Access Compliance Report

Public Rights-of-Way (Curb Ramps)

Intersection ID: 10029688	Main Street: KINGSLEY_VIEW_DR	Cross Street: N/A	Location: W
ADA ID: 07295DF3E3CC	Ramp Type: BlendTrans1	Initial Pass/Fail: Fail	Overall Compliance: No
Codes/Mitigation Info/Possible Solution		Field Measurements/Component Compliance	
Severity Score: 8.75

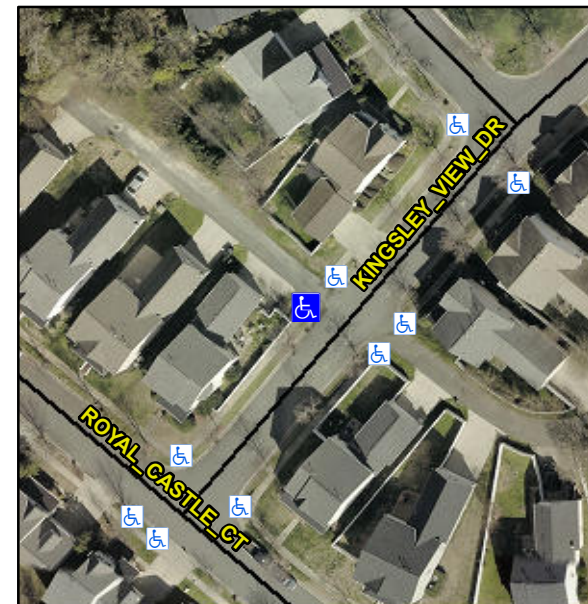
Not Found, R304.5.1

Compliance	Description	Data	Compliance	Description	Data
N/A	Ramp Length (in)	57.0	Yes	BlendTrans Slope (%)	3.1
No	Ramp Width (in)	44.0	Yes	BlendTrans XSlope (%)	1.8
N/A	Flare Type LT	N/A	N/A	Flare Type RT	N/A
N/A	Flare Slope LT (%)	N/A	N/A	Flare Slope RT (%)	N/A
N/A	Flare Traversable LT?	N/A	N/A	Flare Traversable RT?	N/A
N/A	Landing Length (in)	N/A	N/A	DWS Provided?	N/A
N/A	Landing Width (in)	N/A	N/A	DWS Contrast?	N/A
N/A	Landing Slope (%)	N/A	N/A	DWS Length (in)	N/A
N/A	Landing X Slope (%)	N/A	N/A	DWS Full Width?	N/A
N/A	Landing Curb? (Y/N)	N/A	N/A	DWS Offset (in)	N/A
N/A	Shared Landing?	N/A			
N/A	Gutter Ponding?	N/A	N/A	Gutter Slope (%)	N/A
N/A	Gutter Lip Ht (in)	N/A	N/A	Gutter X Slope (%)	N/A
N/A	Painted X Walk1?	No	N/A	Painted X Walk2?	No
	X Walk 1 Direction	To SE		X Walk 2 Direction	To NE
	X Walk 1 Width (in)	N/A		X Walk 2 Width (in)	N/A
	X Walk 1 Slope (%)	2.2		X Walk 2 Slope (%)	5.8
	X Walk 1 X Slope (%)	5.7		X Walk 2 X Slope (%)	2.8

N/A	Ramp inside XWalk1?	N/A	N/A	Ramp inside XWalk2?	N/A
	Road Slope (%)	2.7		Clear Space?	N/A
	Road X Slope (%)	5.5	N/A	Clear Space to XWalk (in)	N/A
N/A	Any Obstructions?	N/A	N/A	Storm Grate/Utility Hazard?	N/A
	Obstruction Type			Storm Grate/Utility Type	
		N/A			N/A
			Yes	Surface Condition? (G/P)	Good
			No	Curb Slope (%)	8.9

Remove & Replace Curb Ramp With Two New Directional Ramps or Equivalent.
